**Data Request 31**

35. *Revise Figures 2.2-2a & 2b Plot Plan in the application to provide the following:*

**PICO POWER PROJECT**  
**PLOT PLAN**

**CONCEPTUAL SIGN PROGRAM**

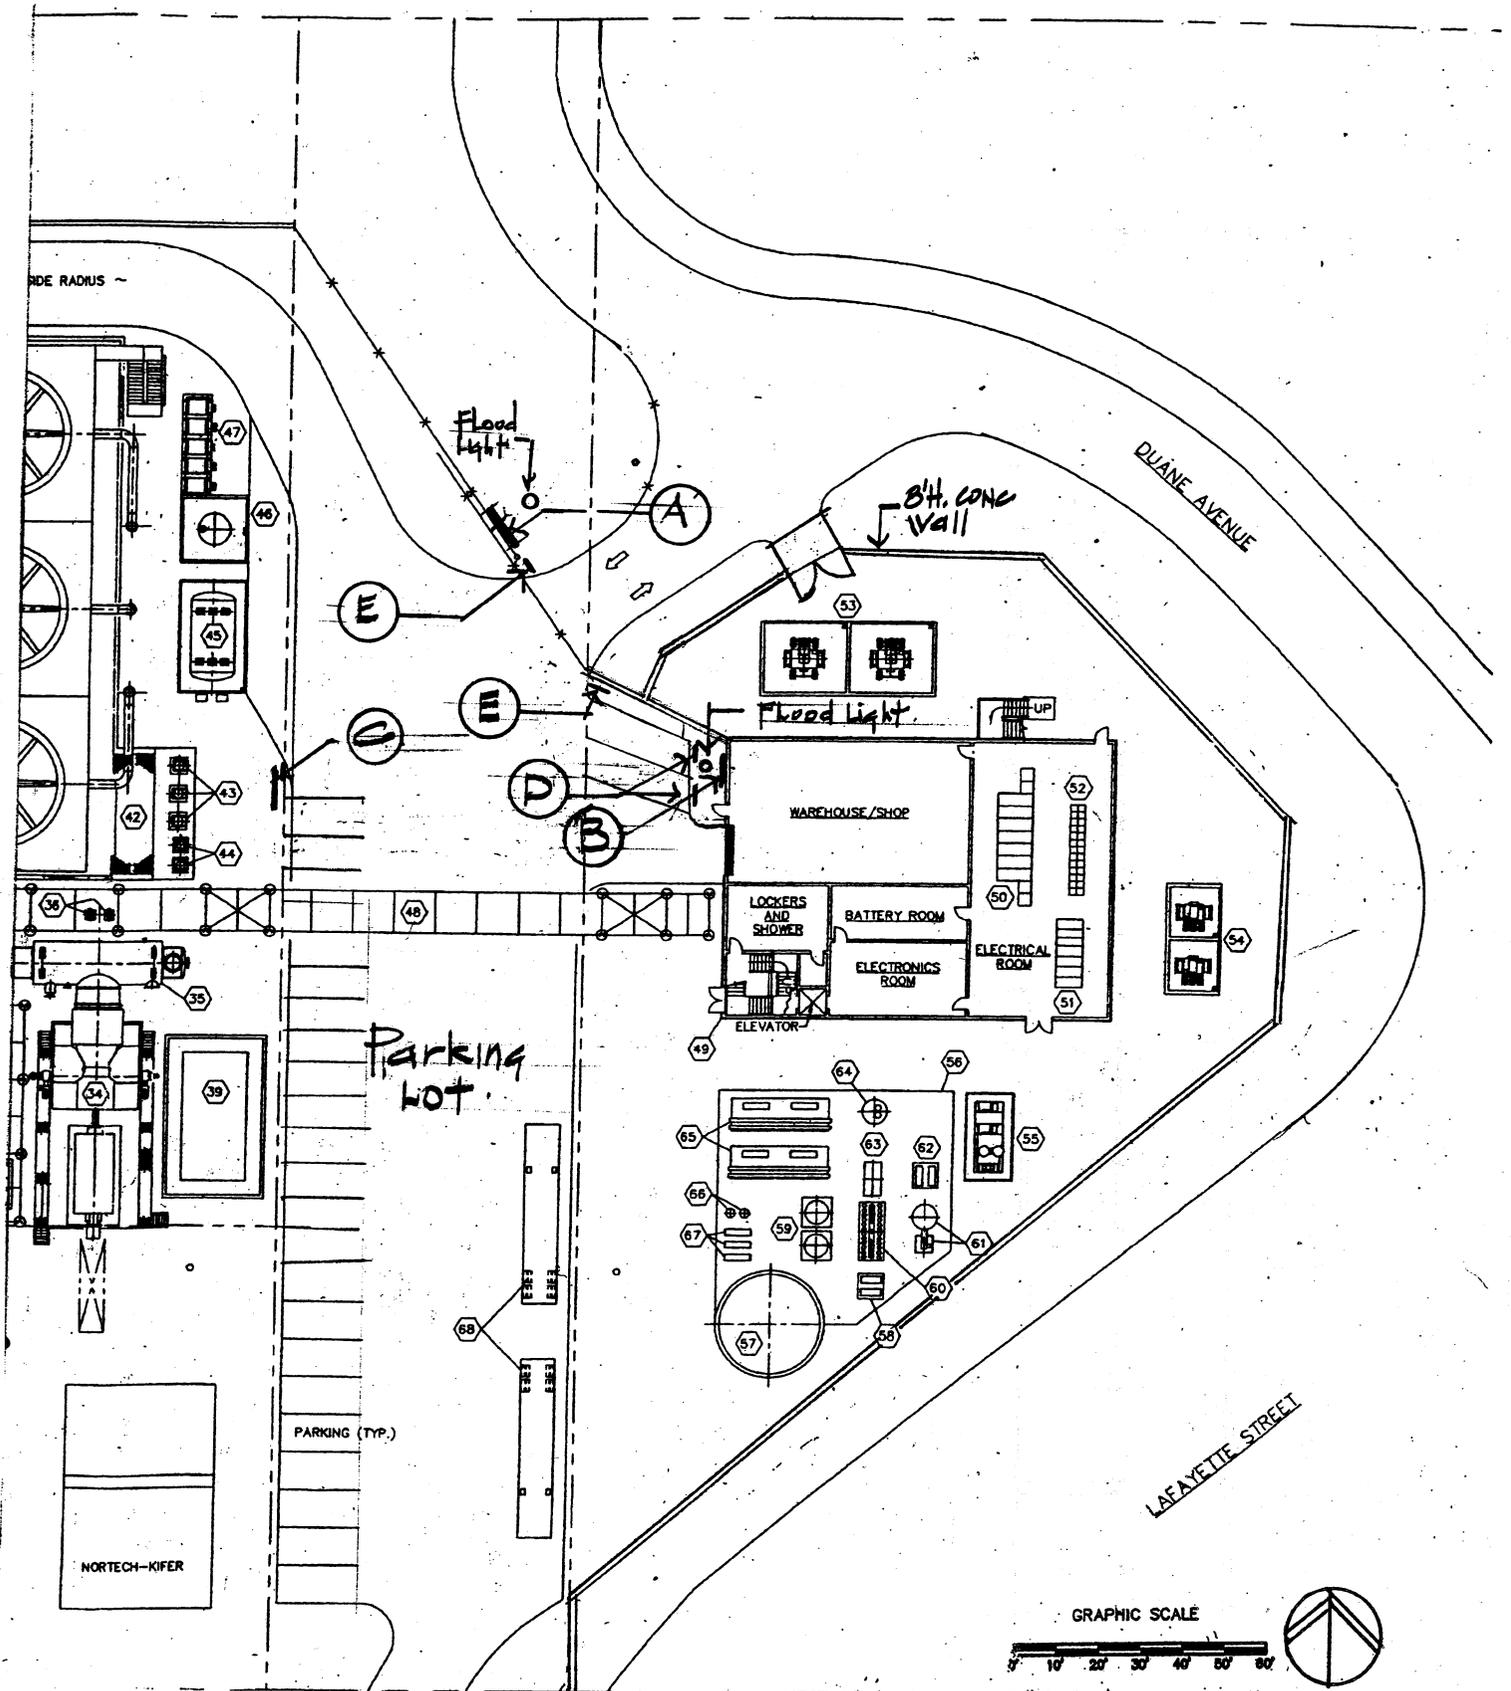
36. *Provide a sign program that includes the following:*

**Response:** The Applicant has developed a preliminary sign program, which contains some conceptual proposals for the signage at the PPP. See attached sign program conceptual design plans. The final sign placement will be determined during the final design phase. All signage will be implemented in accordance with state and City of Santa Clara LORS.

Kennedy/Jenks Consultants  
 City of Santa Clara  
 120mW Pico Power Plant  
**Layout of Gas Metering  
 Facility (GM-4) Plan**  
 K/J Job No. 020519.02  
 December 17, 2002

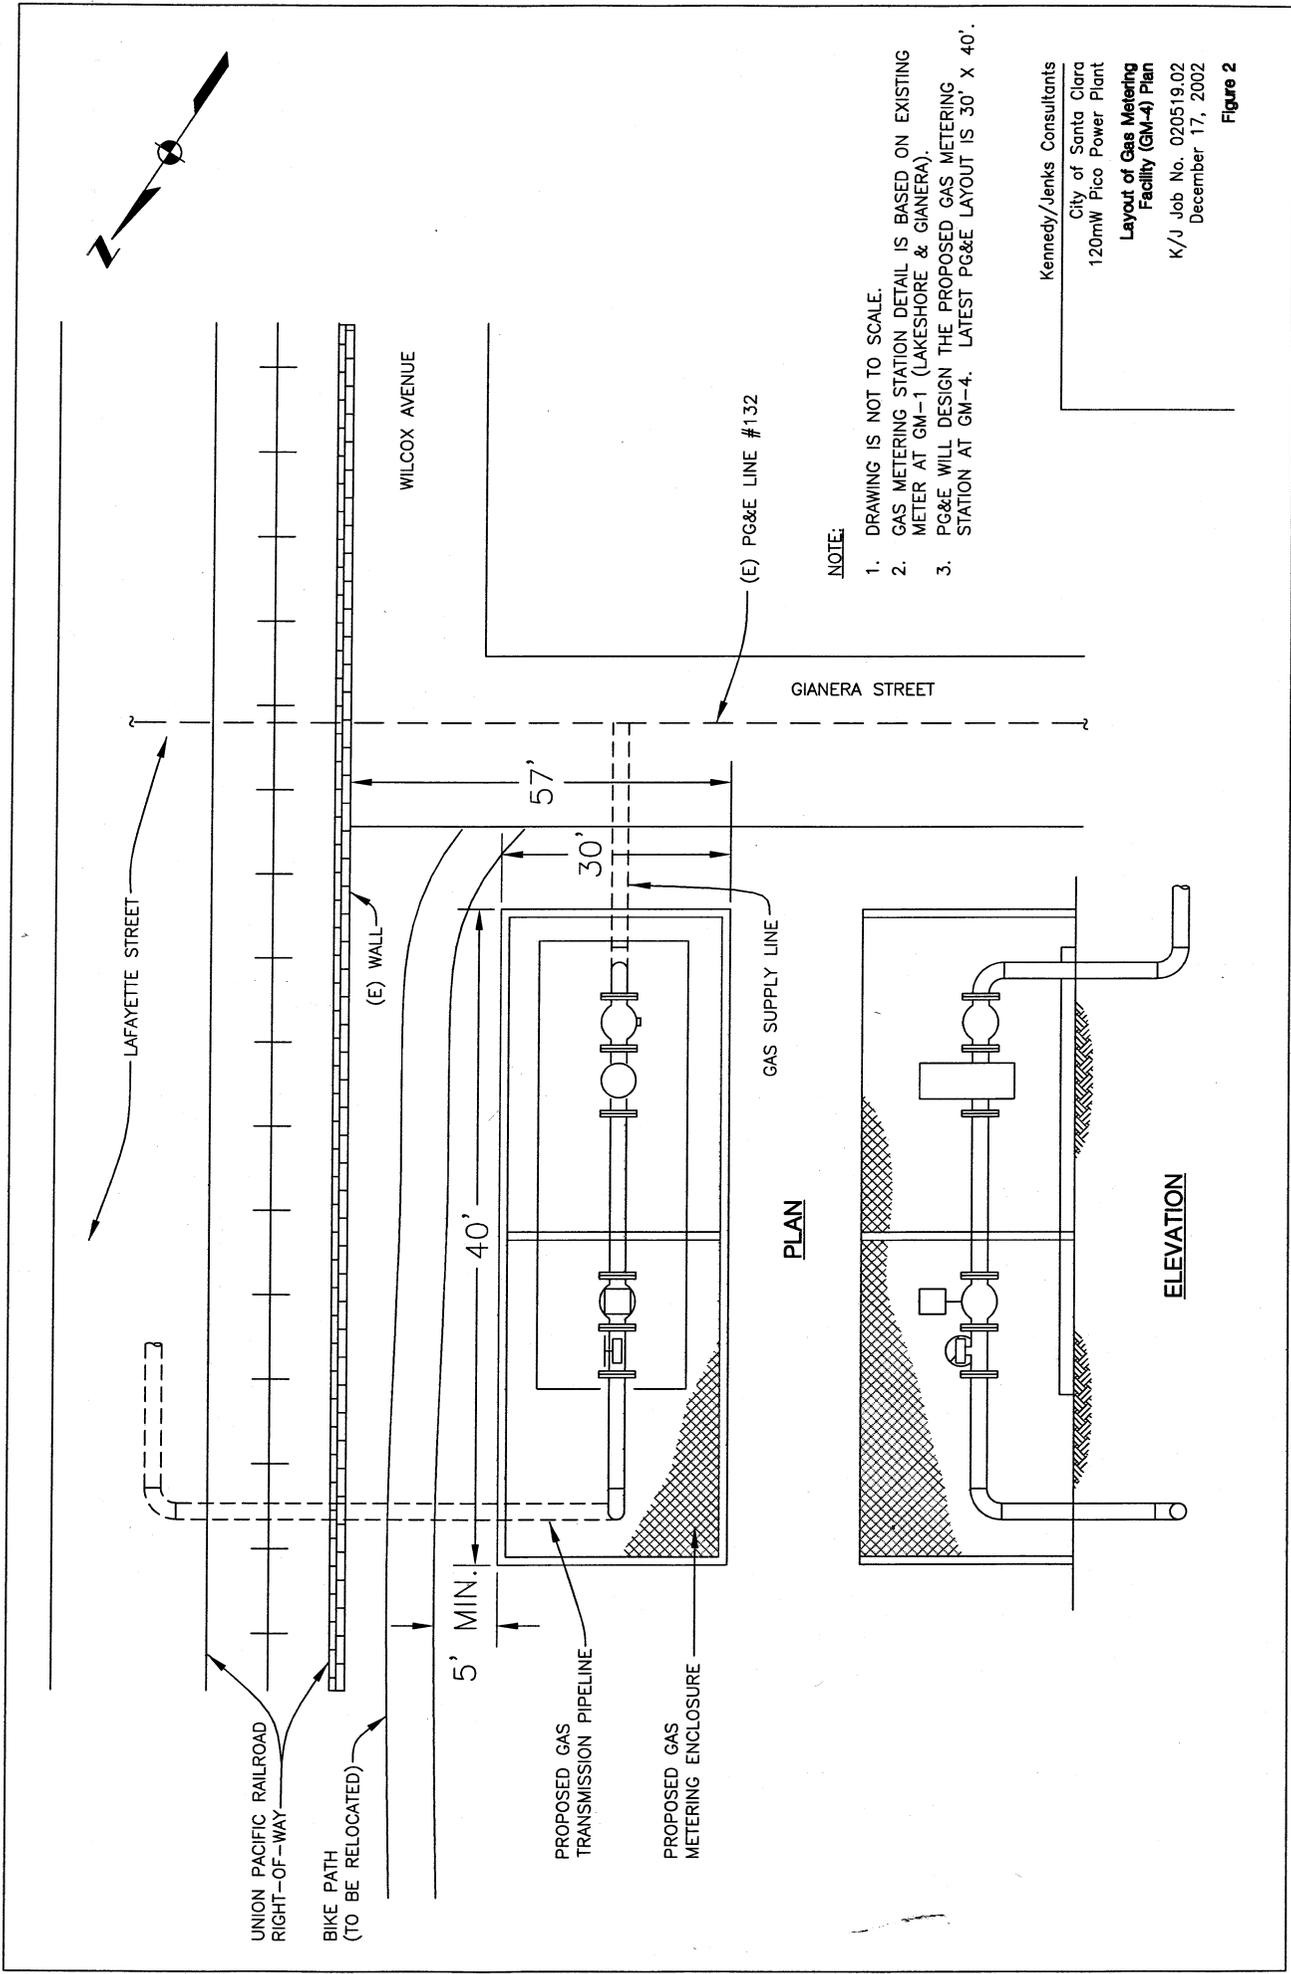
41. *Please provide a copy of the recorded legal description and plot map depicting the realigned bicycle/pedestrian walkway in the area of the metering station.*

**Response:** Attached is a parcel map from the Santa Clara County Assessor's Office, showing that the area of the proposed metering station and bicycle/pedestrian realignment. The passageway within which the metering station is located is an unpaved portion of the former Bassett Road (now Wilcox Avenue) and therefore has no recorded legal description. It is approximately 60 feet wide and extends between the back fencing of residences to the west and the barrier fencing to the Union Pacific railroad tracks to the east. Also attached is a plot map of the area and the proposed gas metering station showing the realigned bicycle/pedestrian path.
